P.A Knit Composite (Extension)

Jamirdia, Habir Bari, Valuka, Mymensingh-2240

12th, 25th October & 29th November 2021

Observations

Stress in foundation exceeds normal design limit

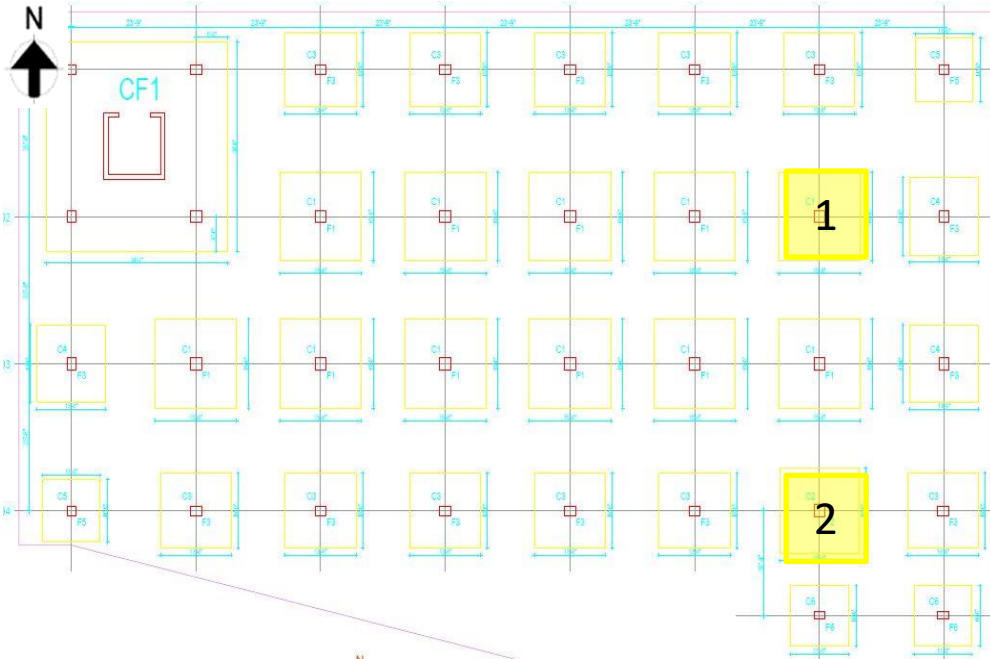
Cursory calculation indicates that footings are stressed above normal design limit considering 3 kPa floor live load (mezzanine) and minimum allowable bearing capacity 2 ksf (BNBC Ch-3, Table -6.3.5). The building engineer is required to review design, load, column & footing stress.

Stressed column/foundation layout

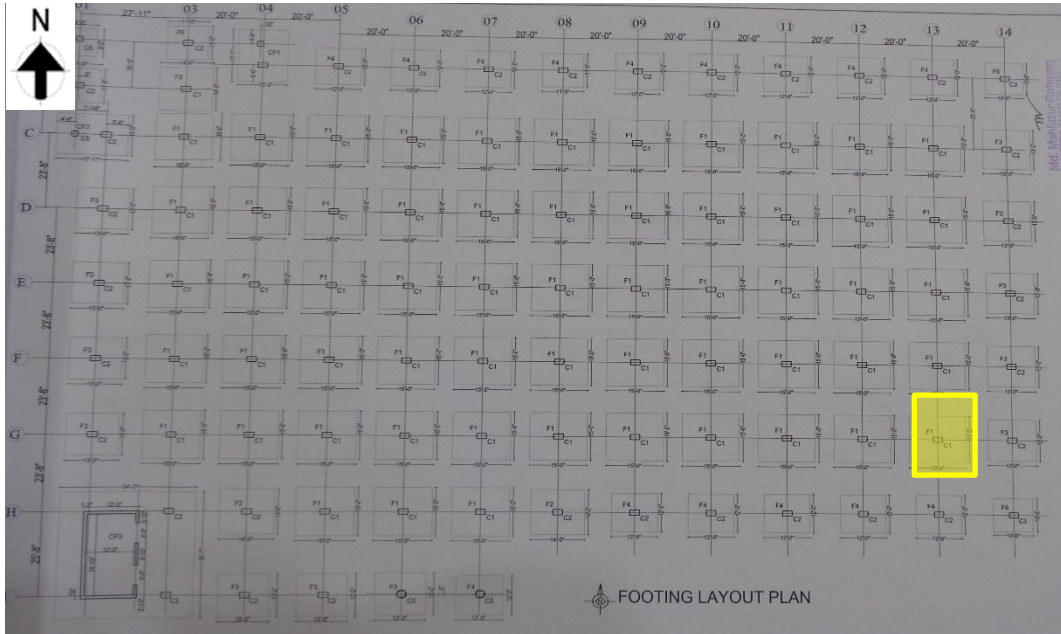
Cursory calculation indicates that stress exceeds the normal design limit for both columns & foundations in marked location-1 and only for column at marked location-2 considering the floor live load (7 kPa for first & second floor, 4 kPa for typical floors as per load plan), minimum concrete strength based on aggregate type and allowable soil bearing capacity 20 T/m². Building engineer is required to review the design, loads and column/foundation stresses based on in-situ concrete strength.

Bracing Layout

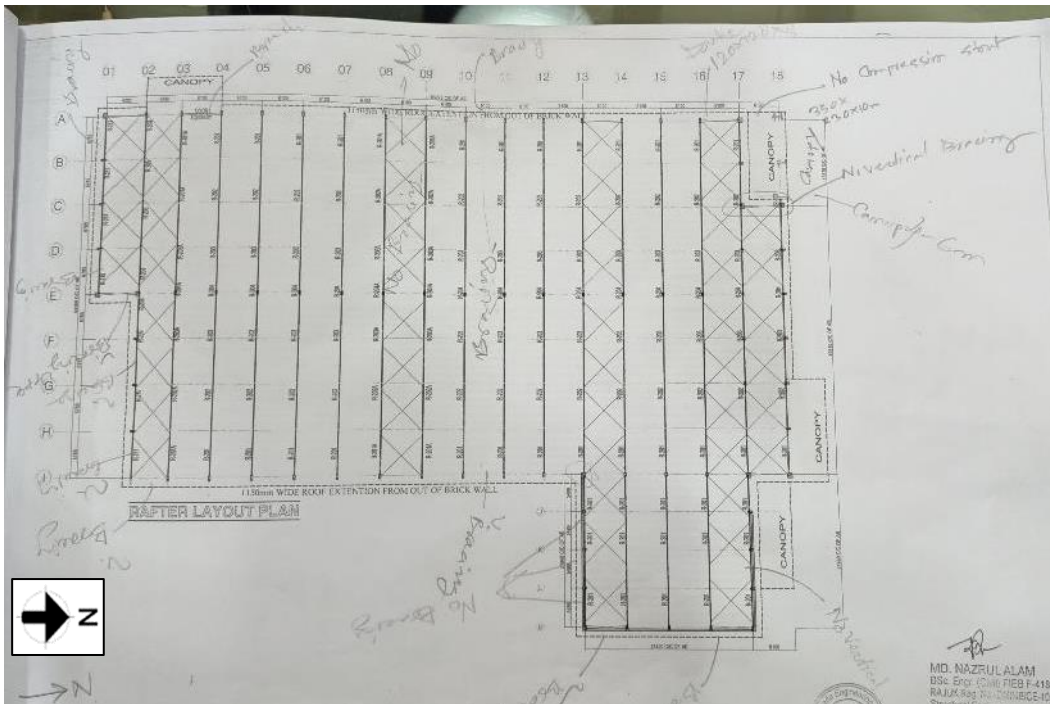
lateral load transfer media observed discontinued in roof. Also, bracing system are found mismatch with bracing layout. As part of Engineering Assessment (EA) building engineer is required to check the stability system of the Building and design the size & position of necessary compression element accordingly.

No compression member at grid 17~18

Bracings are found mismatch with layout

Wall/roof bracing provided at only one bay

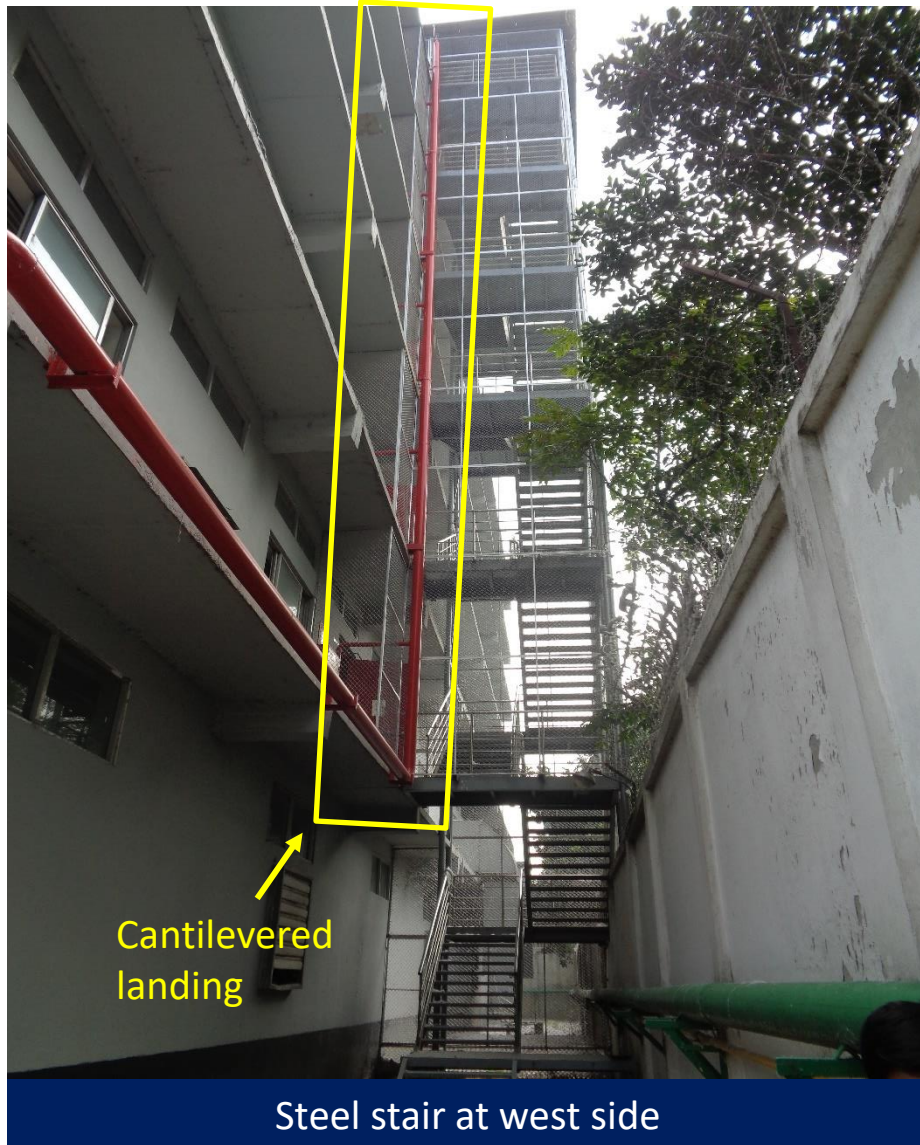
No load transfer media provided; wall/roof bracing not provided at rest of the bays

No load transfer media is provided from frame to frame along long direction. In addition, wall/roof bracing is provided only at one bay but not provided at rest of the bays. Therefore, lateral stability system along long direction is incomplete. Building engineer is required to check the lateral stability of the shed against the lateral loading.

Gap observed in Beam- Column connection

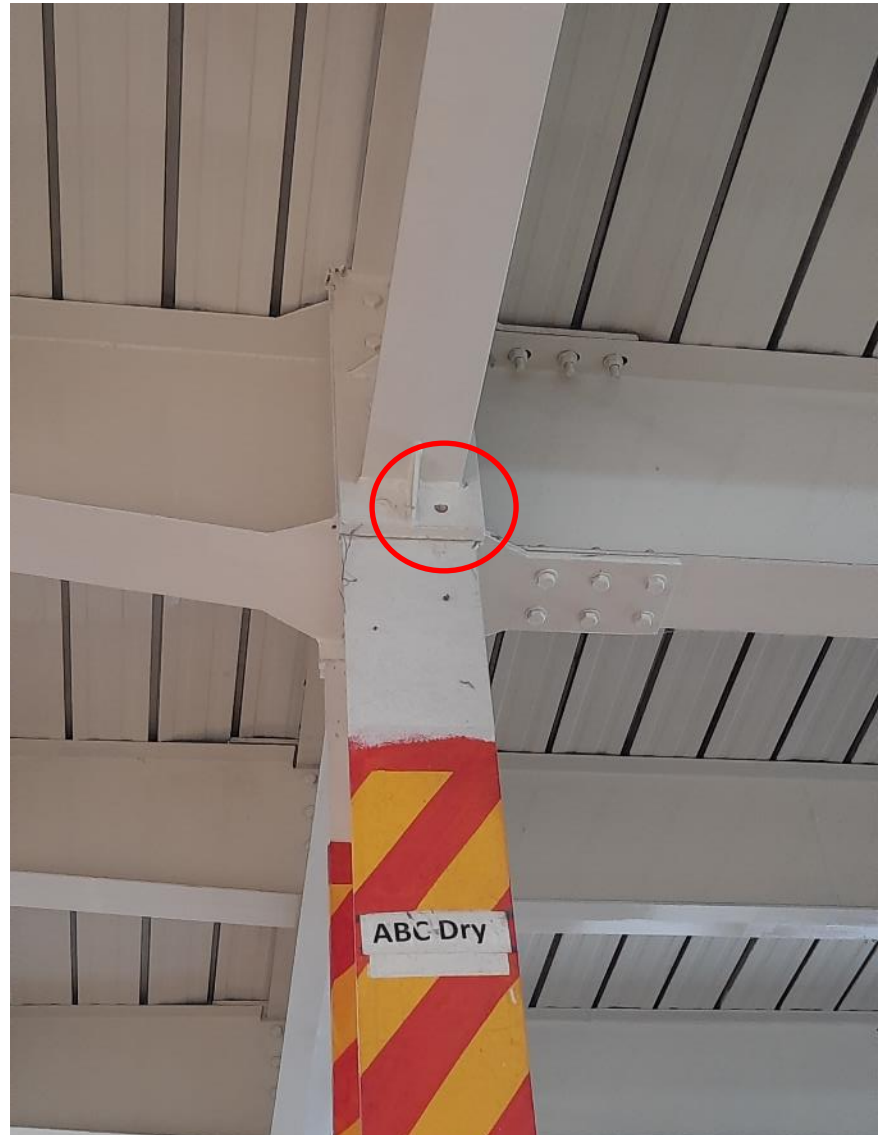
Significant gaps observed at column-beam joint at several locations. Building engineer is required to carry out suitable remedial works.

Layout Plan

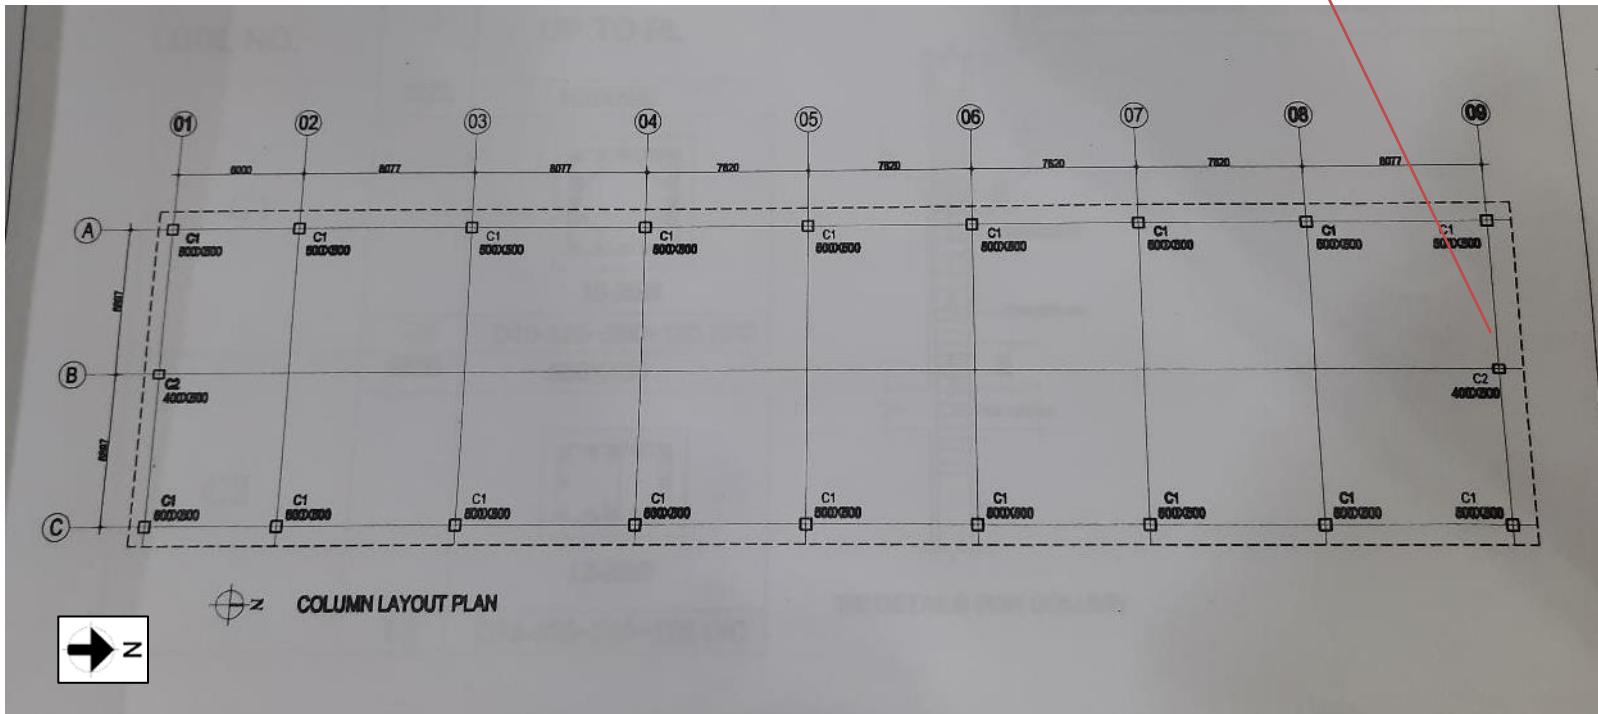
No structural drawings details were found for the mezzanine floor. Undocumented extension was observed at Northwest corner. Also, connection details were not available in the provided drawings. Moreover, a separate single storied chemical building was found inside the shed.

Undocumented extension

Roof layout

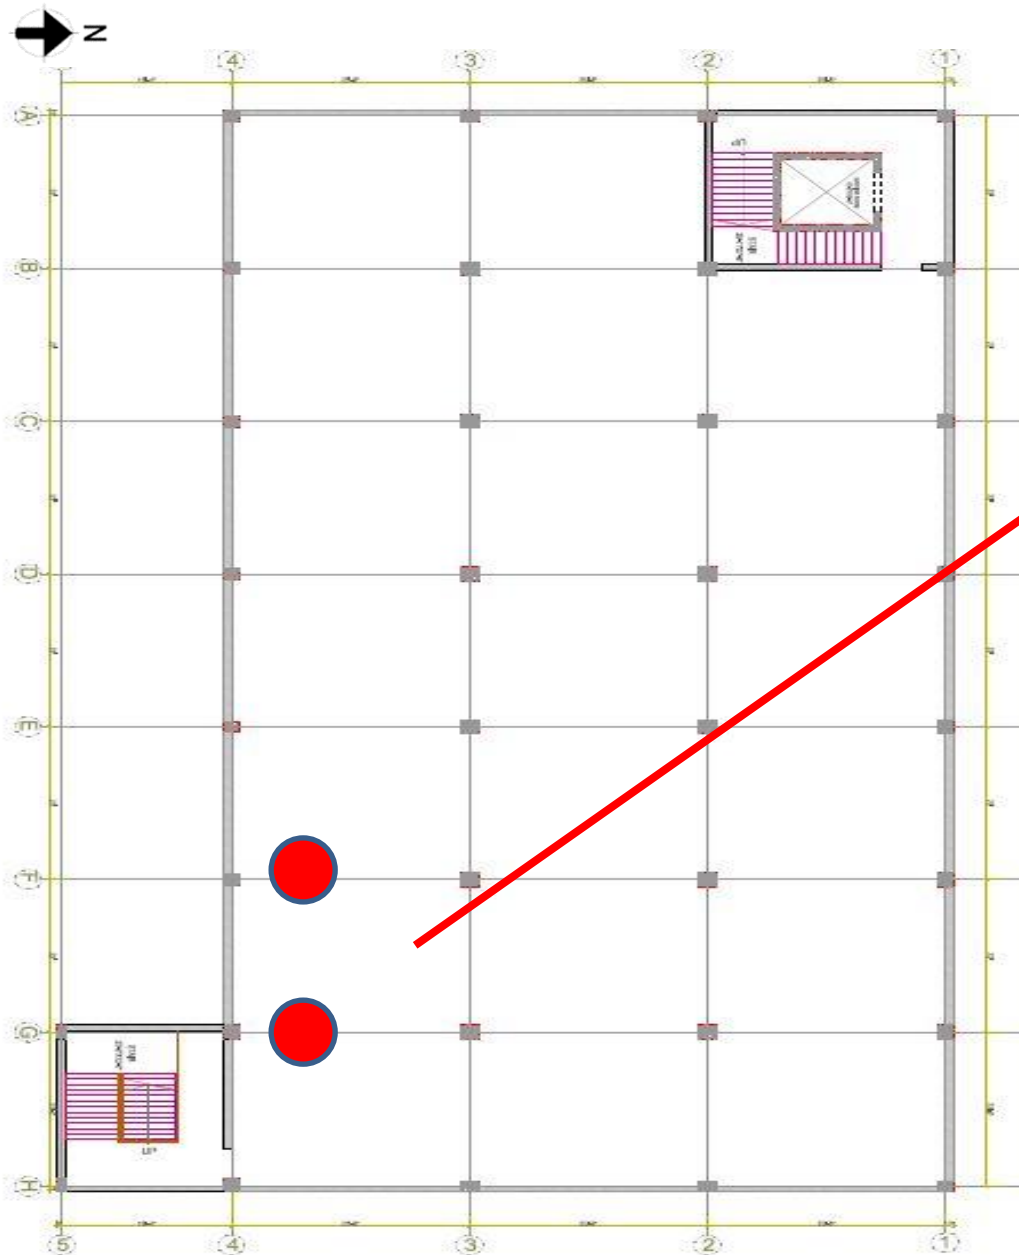
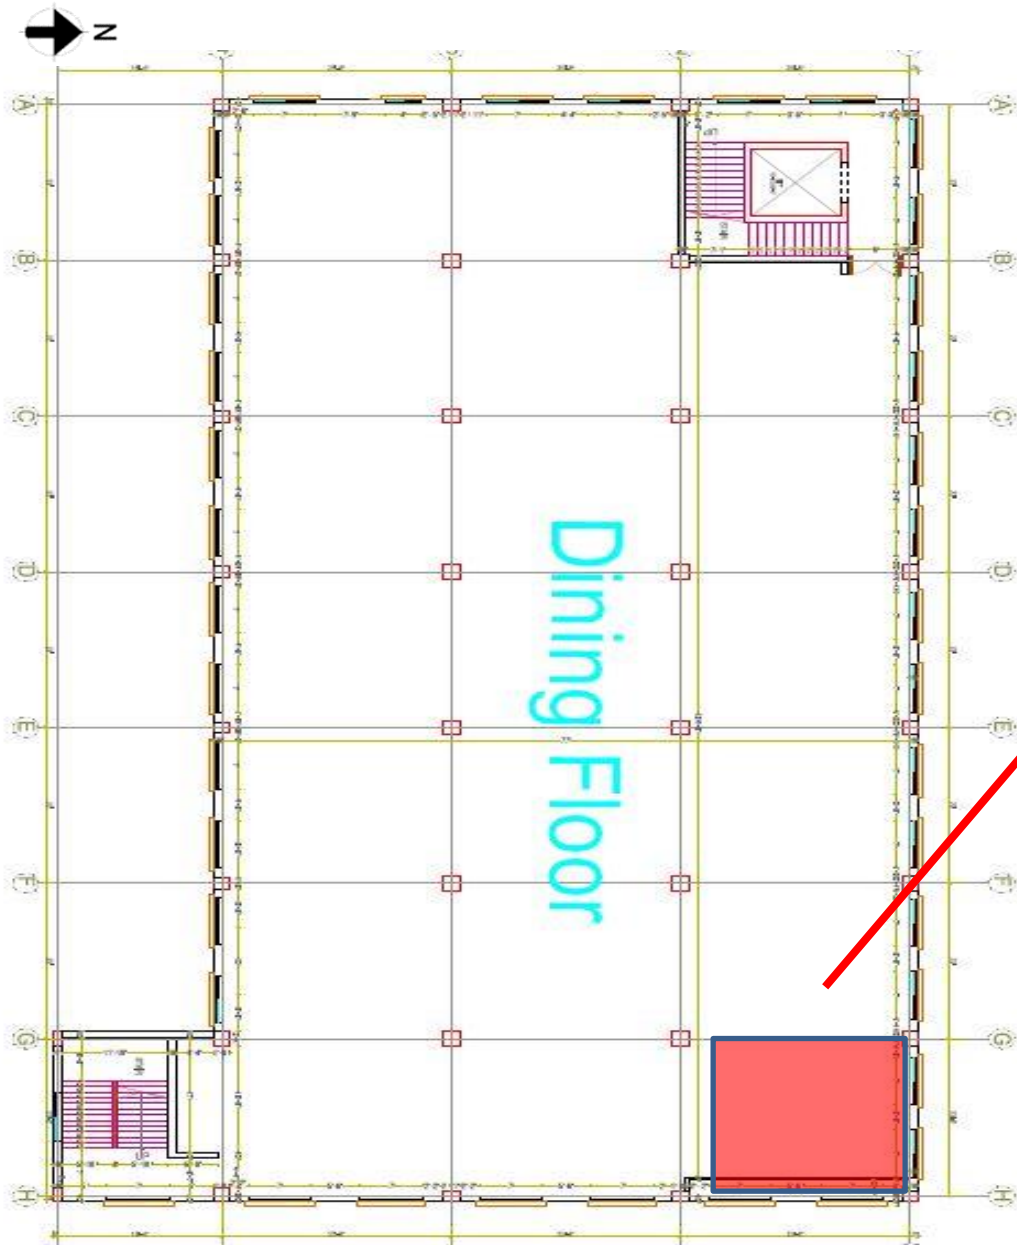
Plastic water tank (5000 liter each)

Two plastic water tank having capacity of 5000 litre each found on roof slab which were not shown in roof layout. Building engineer is required to update the as-built drawing as well as check the capacity of roof beam-slab considering the point load.

Discontinuous truss member

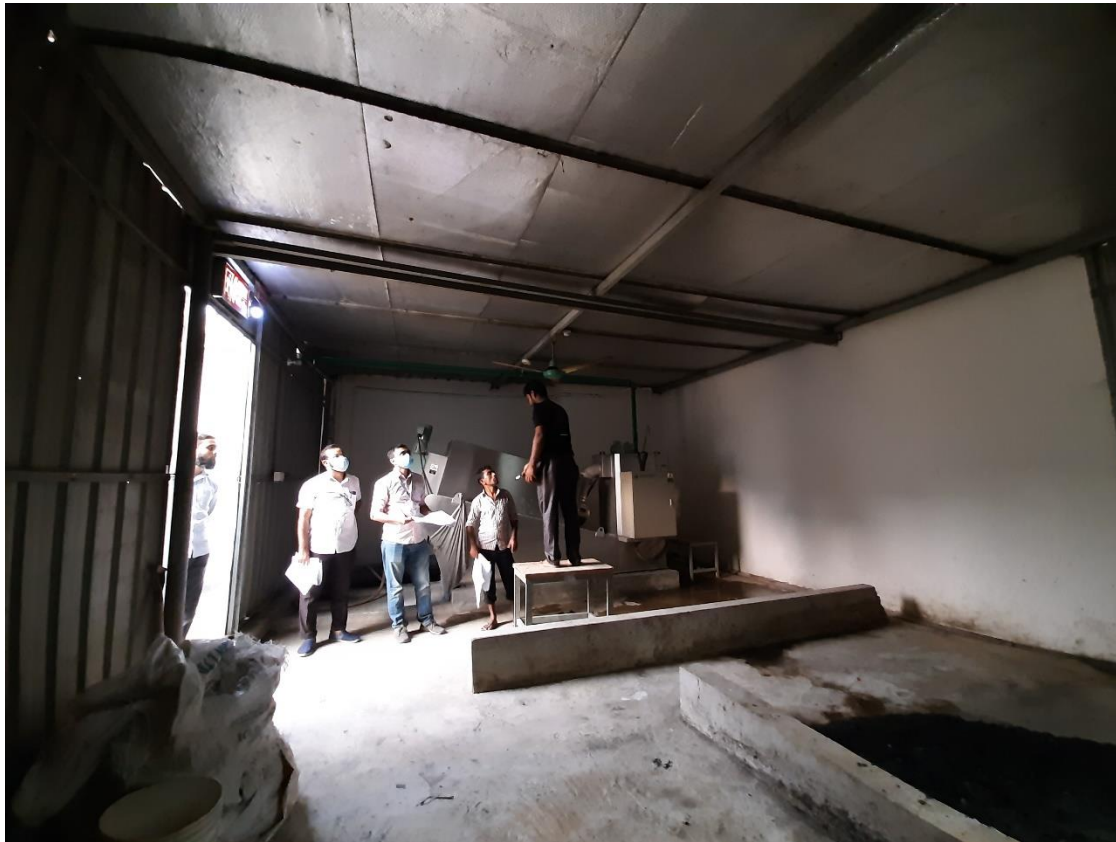
Diagonal truss member has been cut down due to fire hydrant discharge pipe. Building engineer is required to repair the truss frame with suitable method.
